From:	Nicholas.Rubino@lovell.co.uk
Sent:	13 December 2010 08:09
To:	Peter Barnett
Cc:	nick.lizrubino@talktalk.net
Subject:	26 Wilmot Road Shoreham on Sea. Proposed Conservatory revisions North elevation 13/12/2010
Attachments:	20101213074248273_0002.pdf; 20101213074248273_0001.pdf
Importance:	High
Follow Up Flag:	Read
Due By:	13 December 2010 03:00
Flag Status:	Flagged

Re: Proposed Conservatory to North Elevation & Porch to east elevation at 26 Wilmot Road, Shoreham

PROPOSED CONSERVATORY + PORCH 26 HILLMOT RD.

DWG - AA1 - 01 B

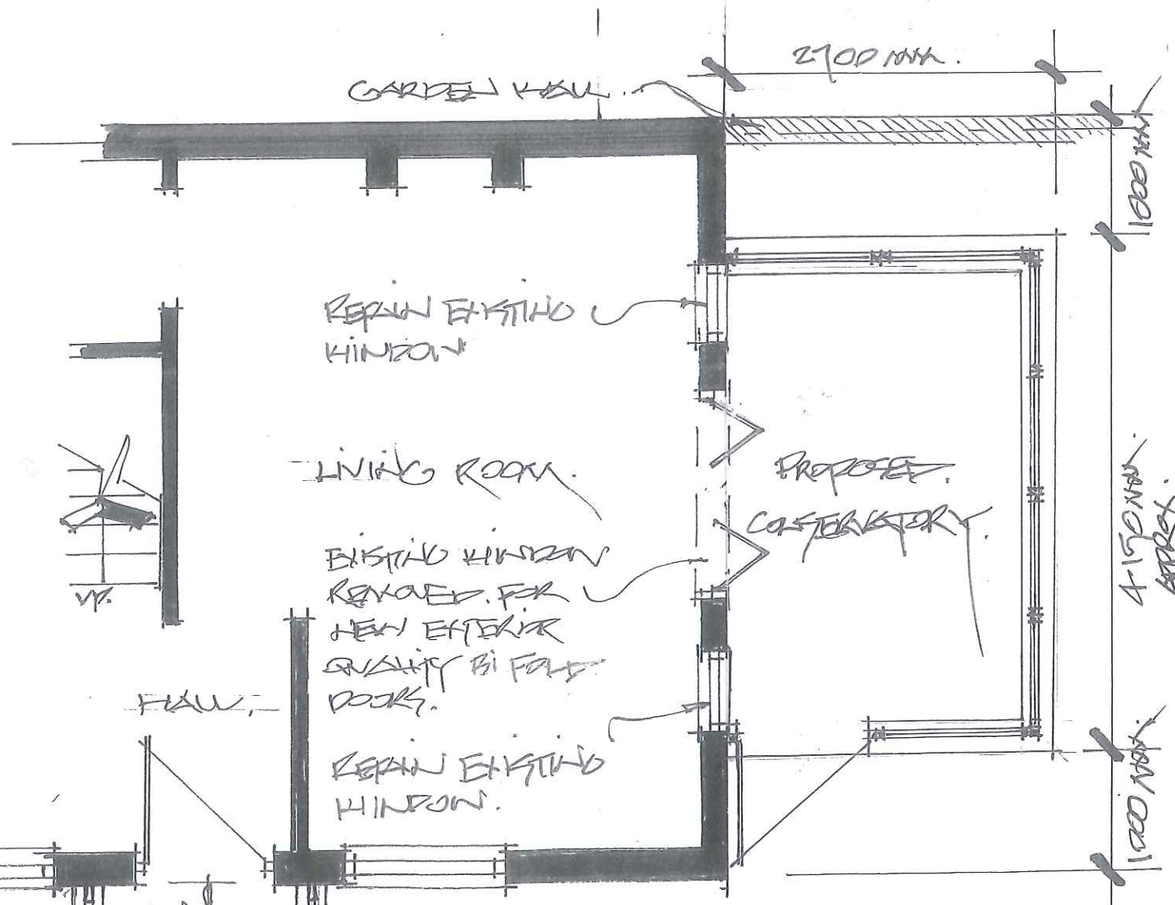
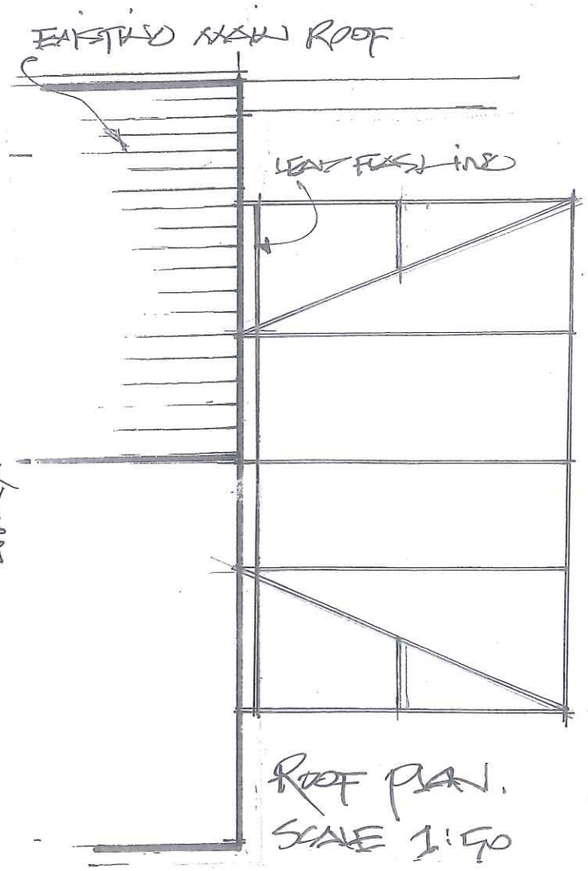
The overall projection is now revised from 3m to 2.7m. The end walls have also been revised reducing to 1m in from each side.

I have not retained the chamfered corner features to optimise on internal usable space.
To retain the chamfered corners would be unpractical given the reduction in size and also not cost affective for my Client.
Please also note I have reduced the height of the porch roof to match proposed conservatory roof height.
